ISC-C1 Rack

Title ISC System Wiring Diagram		
Size B	Number D1900511	Revision V9
Date: 10/31/2023	Sheet of 1	38
File: C:\Users\...ISC_C1_SH1.SchDoc	Drawn By: Filiberto Clara

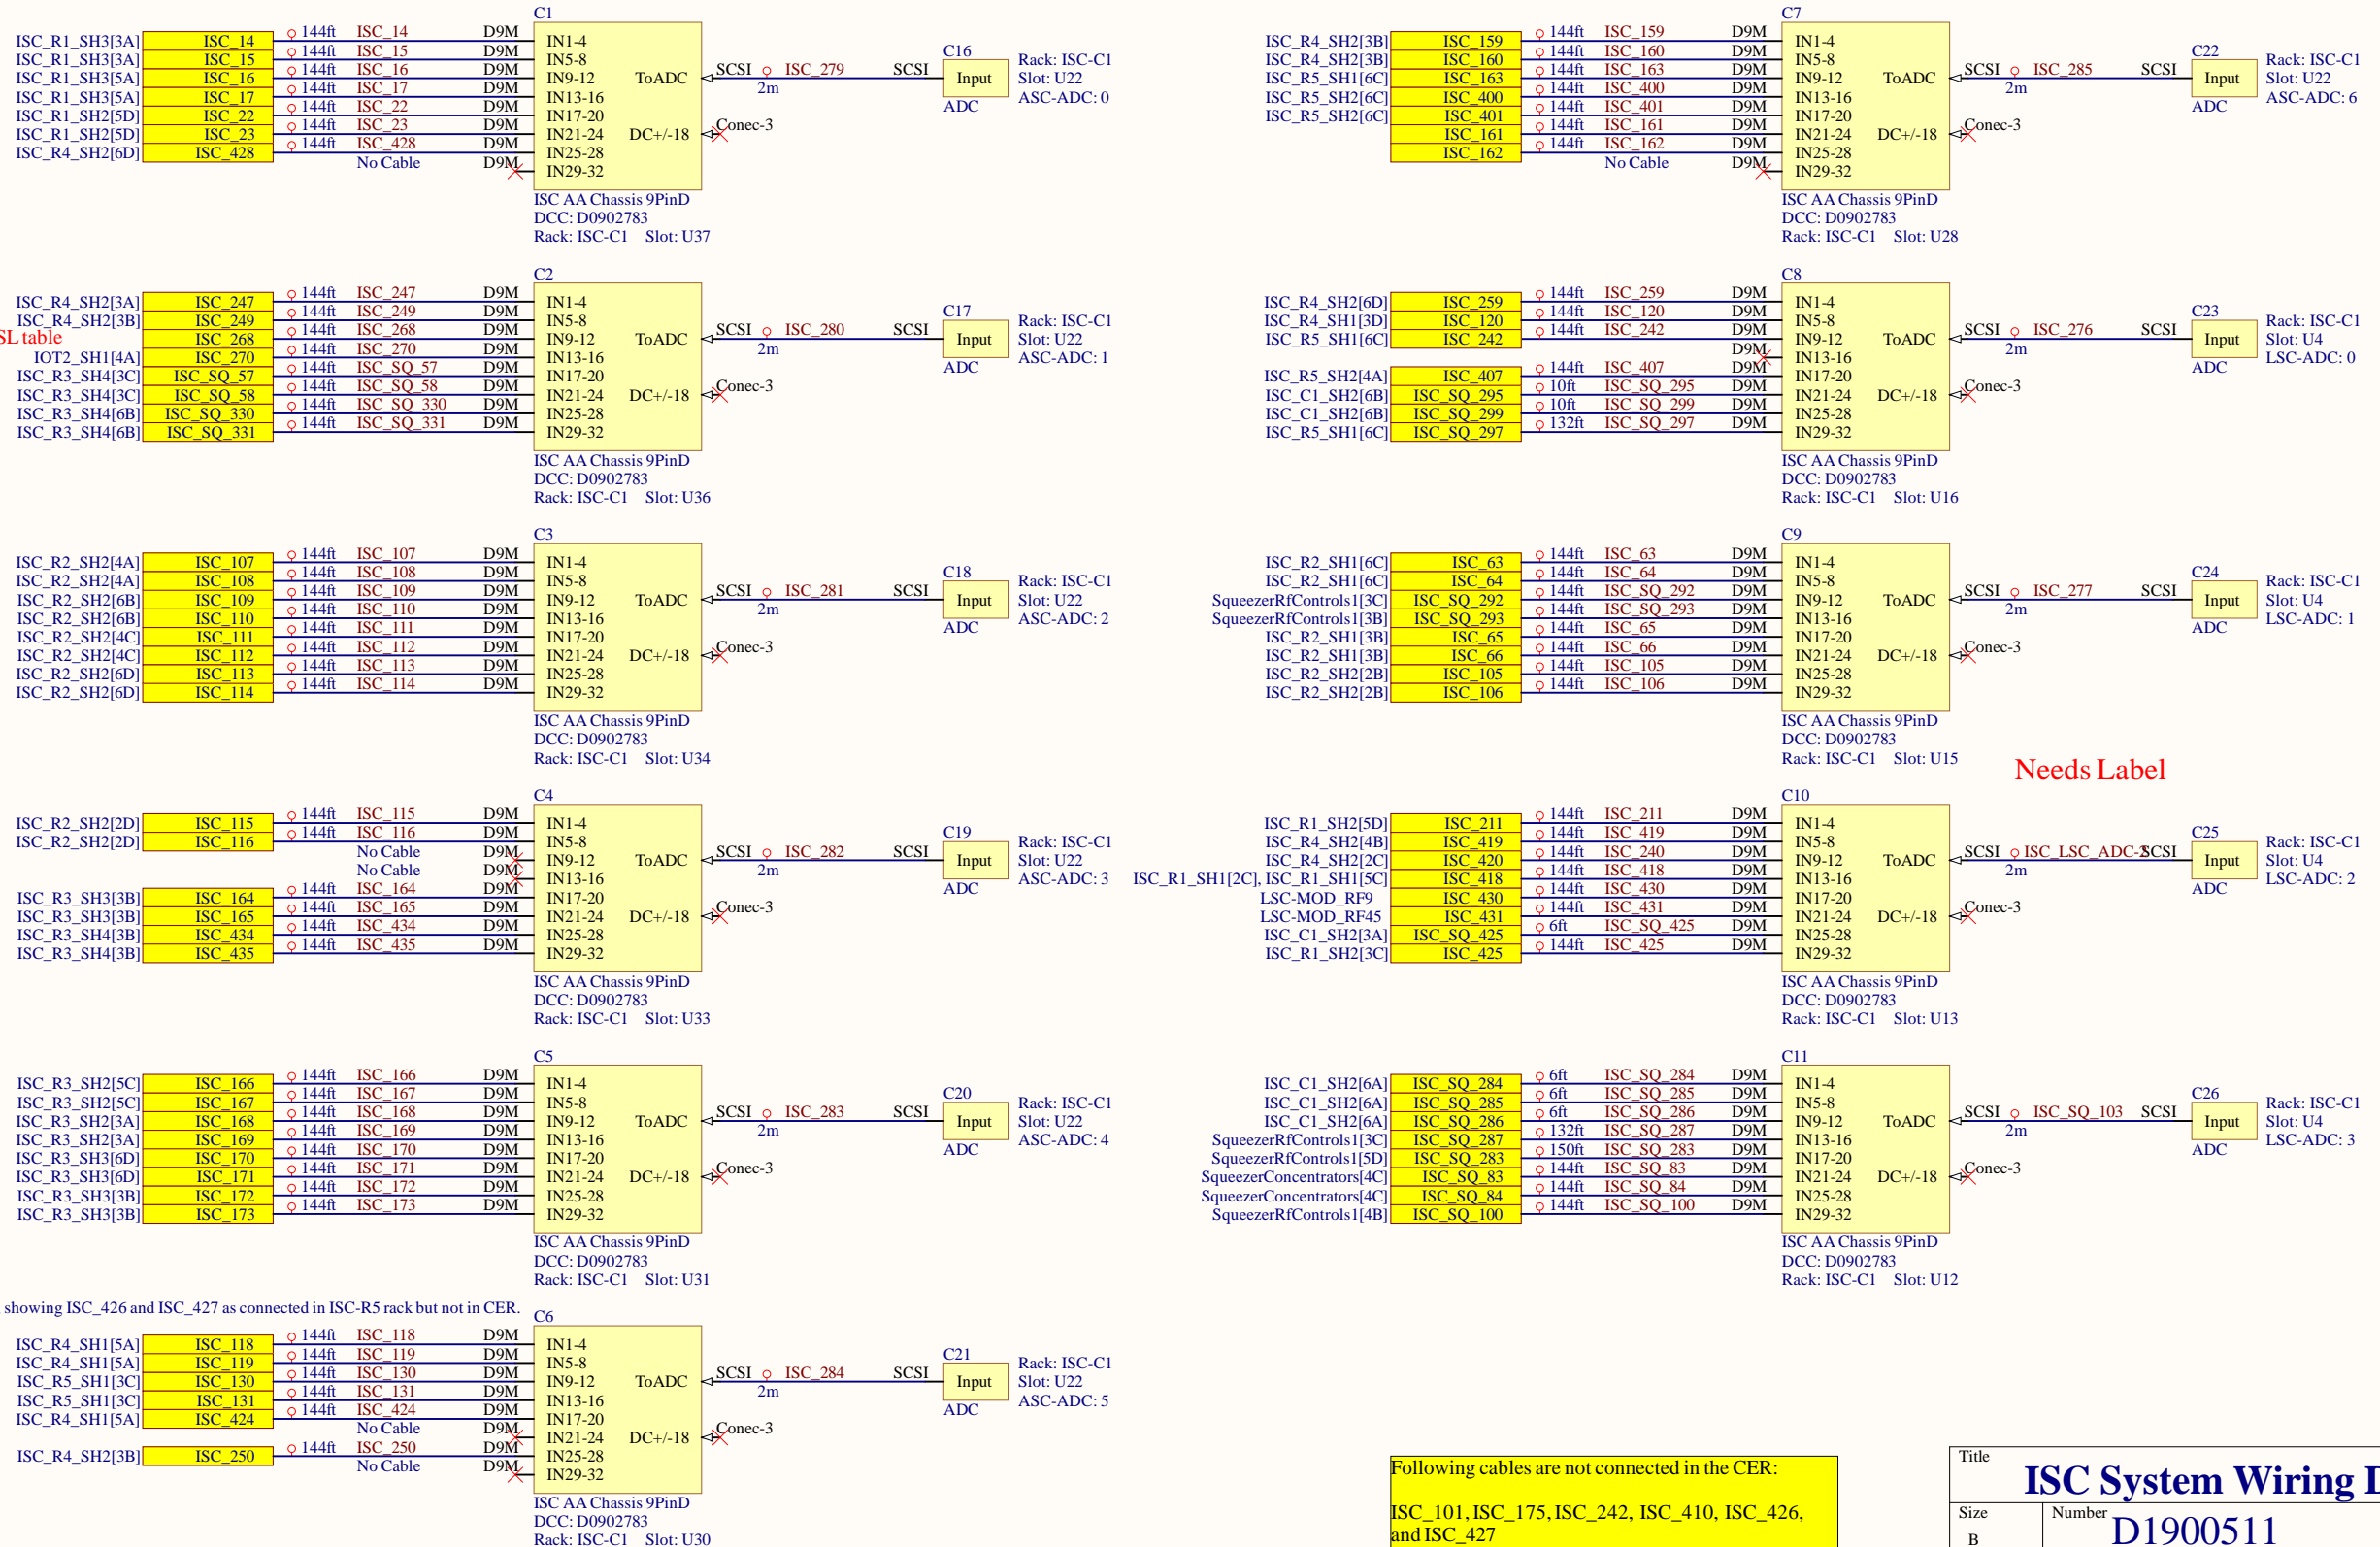
Following cables are not connected in the CER:
 ISC_101, ISC_175, ISC_242, ISC_410, ISC_426,
 and ISC_427

Title		
ISC System Wiring Diagram		
Size	Number	Revision
B	D1900511	V9
Date:	10/31/2023	Sheet of 7 38
File:	C:\Users\...ISC_C3_SH3.SchDoc	Drawn By: Filiberto Clara

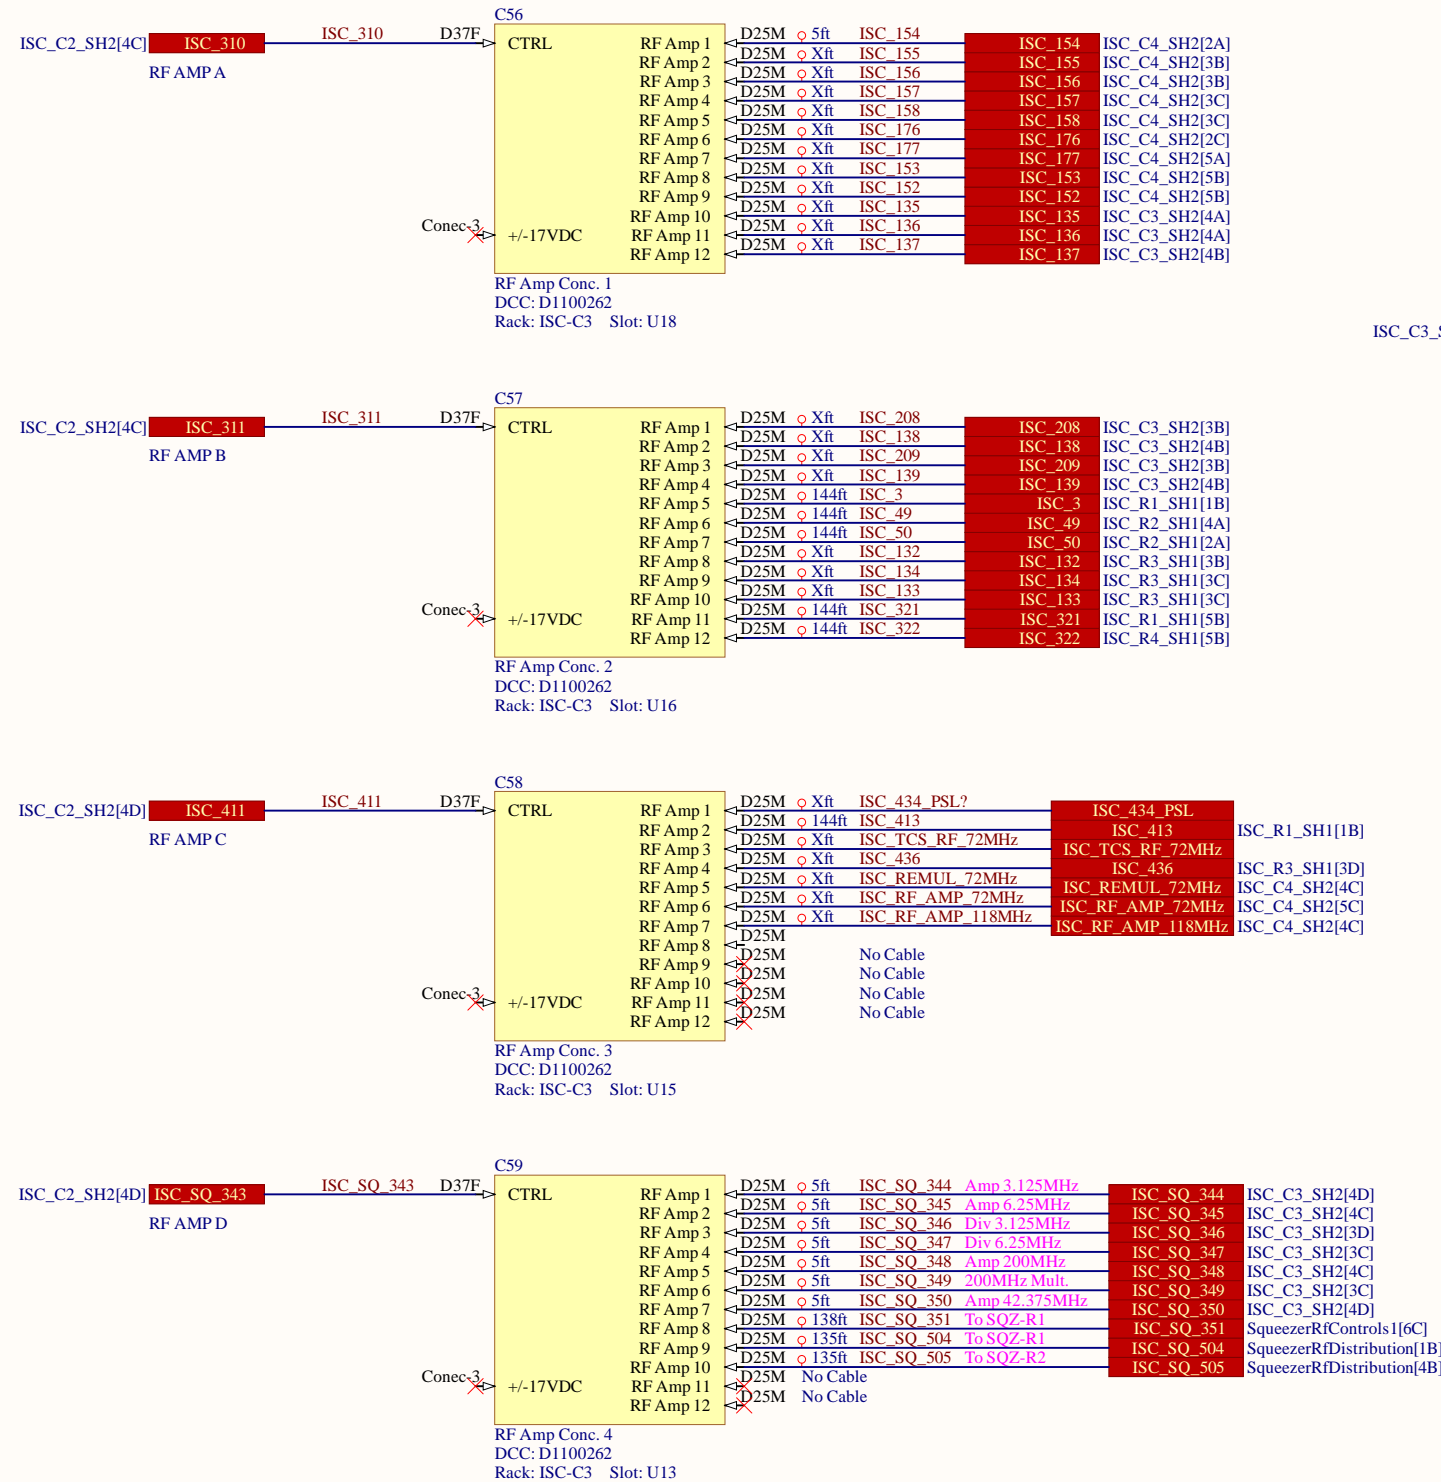
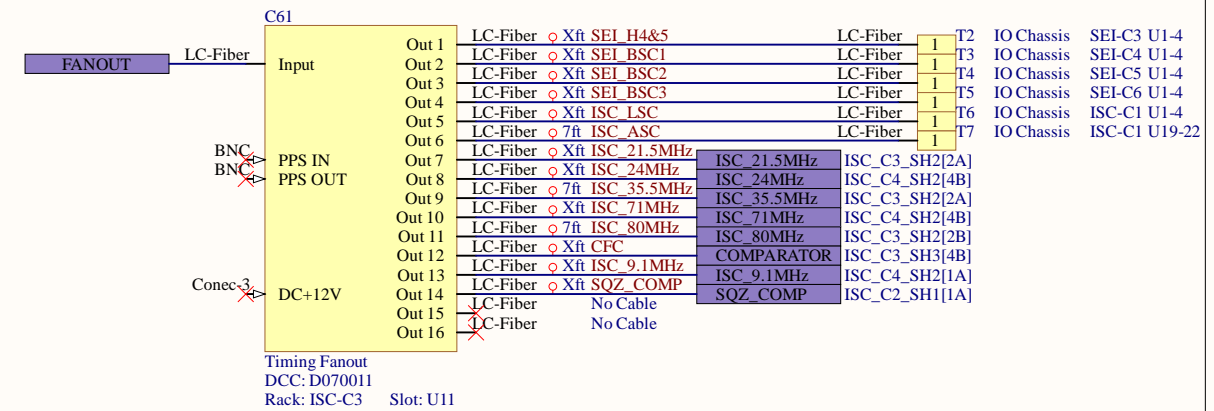
Need Locations of other ends.
 SEI IO Chassis

Title			
ISC System Wiring Diagram			
Size	Number	Revision	
B	D1900511	V9	
Date:	10/31/2023	Sheet of	38
File:	C:\Users\...ISC_R1_SH2.SchDoc	Drawn By:	Filiberto Clara

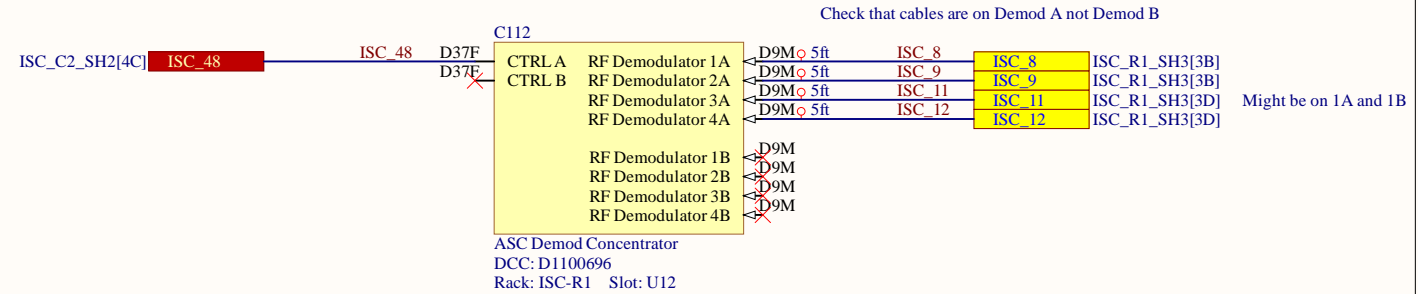
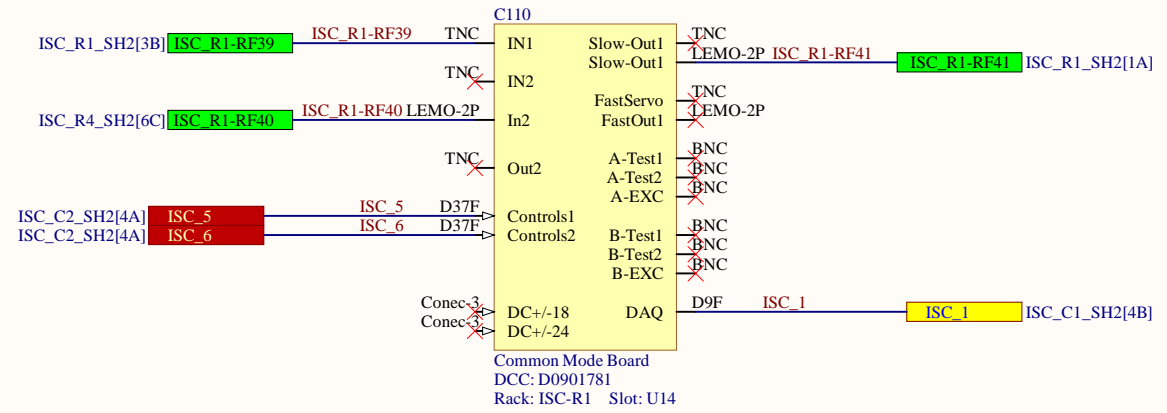
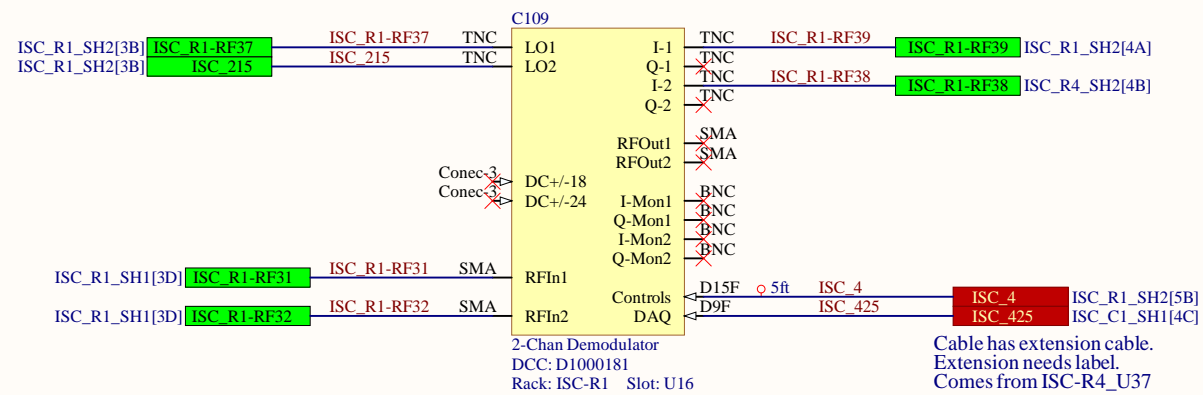
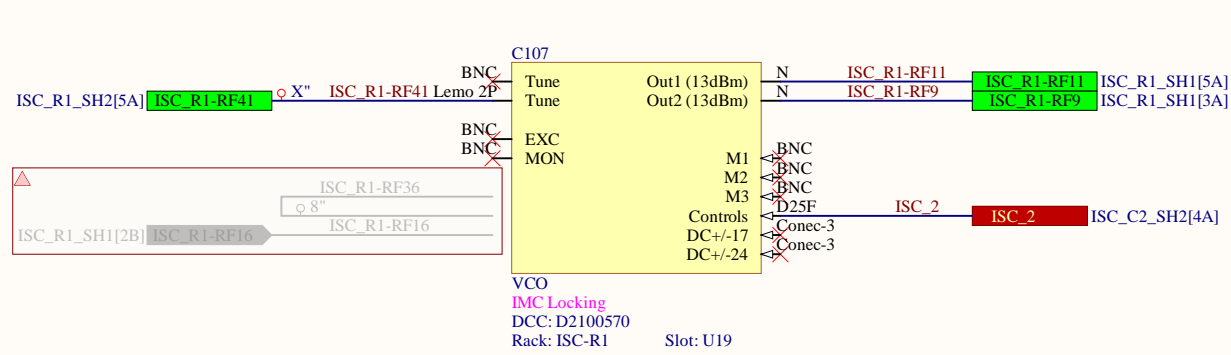
Need to Locate other end

Title		
ISC System Wiring Diagram		
Size	Number	Revision
B	D1900511	V9
Date:	10/31/2023	Sheet of 2 38
File:	C:\Users\...ISC_R1_SH3.SchDoc	Drawn By: Filiberto Clara

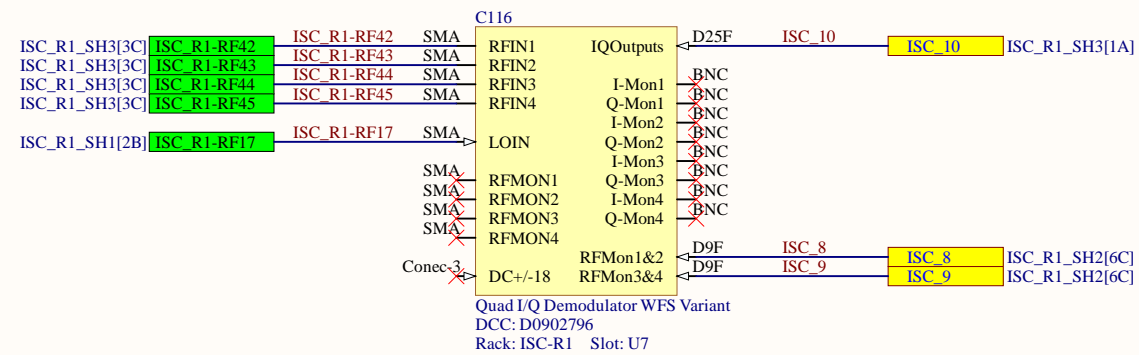
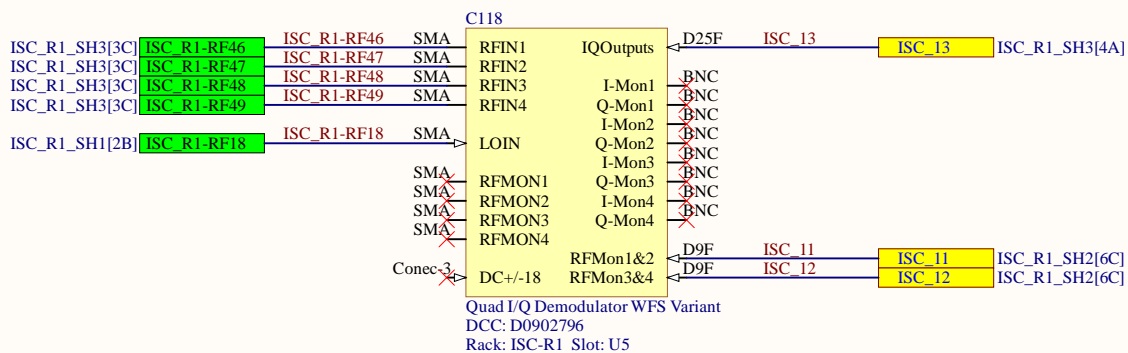
Need to locate other end

434/435 already used
ASC-POP_X_PIT/YAW

Title		
ISC System Wiring Diagram		
Size	Number	Revision
C	D1900511	V9
Date:	10/31/2023	Sheet of 6 38
File:	C:\Users\...ISC_R4_SH2.SchDoc	Drawn By: Filiberto Clara

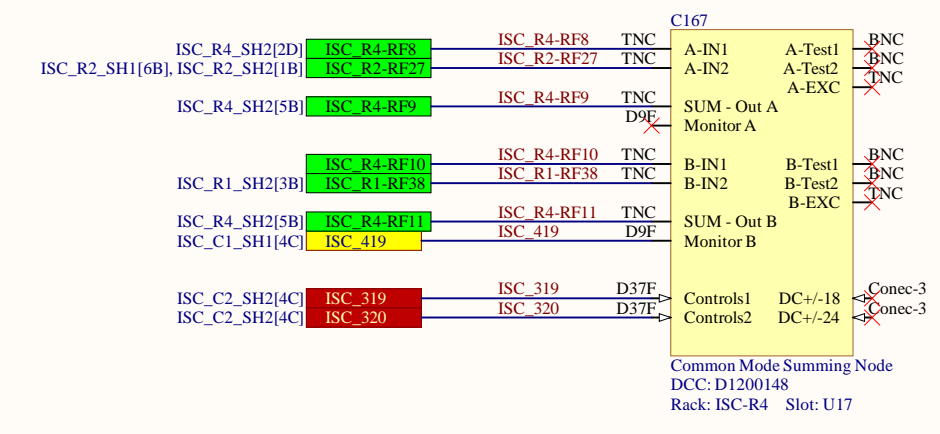
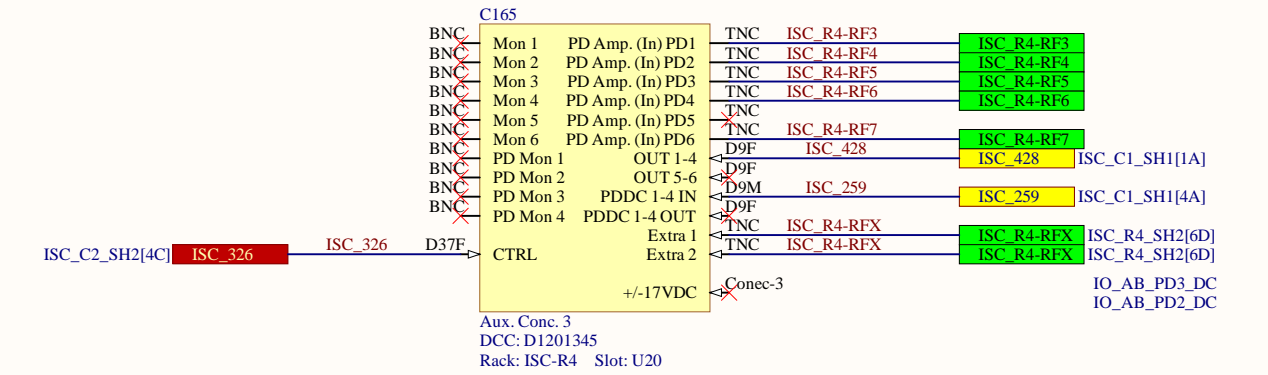
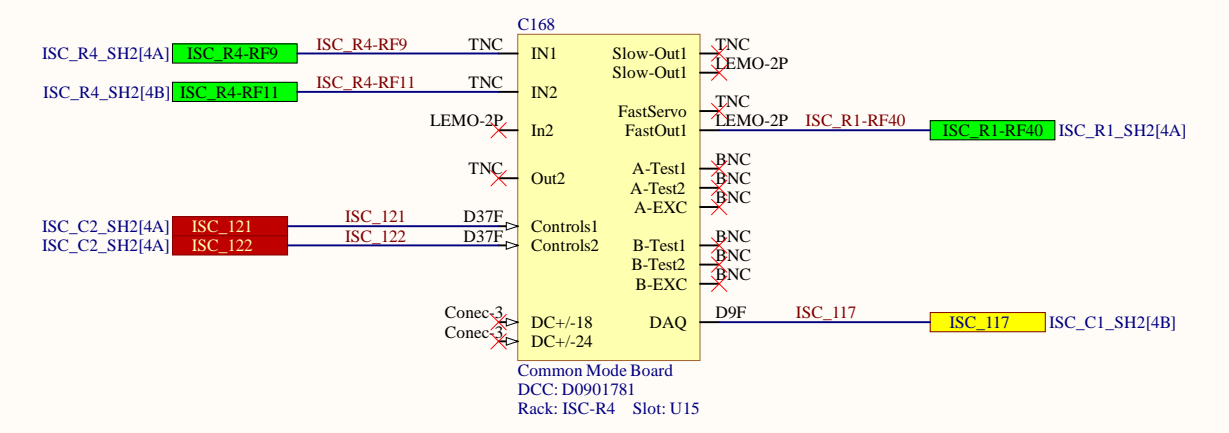
Do we need Sat Amp Included
 U23
 ISC_194 Coild Drive in CH1-4
 ISC_195 Coild Drive in CH5-8
 ISC_125 PD Out CH1-4
 ISC_126 PD Out CH1-4

Cable in the back.
 ISC_228
 ISC_229

Otherside not labeled. RED
 Otherside not labeled. Green
 Otherside not labeled. R4 ISC1
 Otherside not labeled. R4 ISC2
 Otherside not labeled. Old label H1_ALS_PSL_PD1
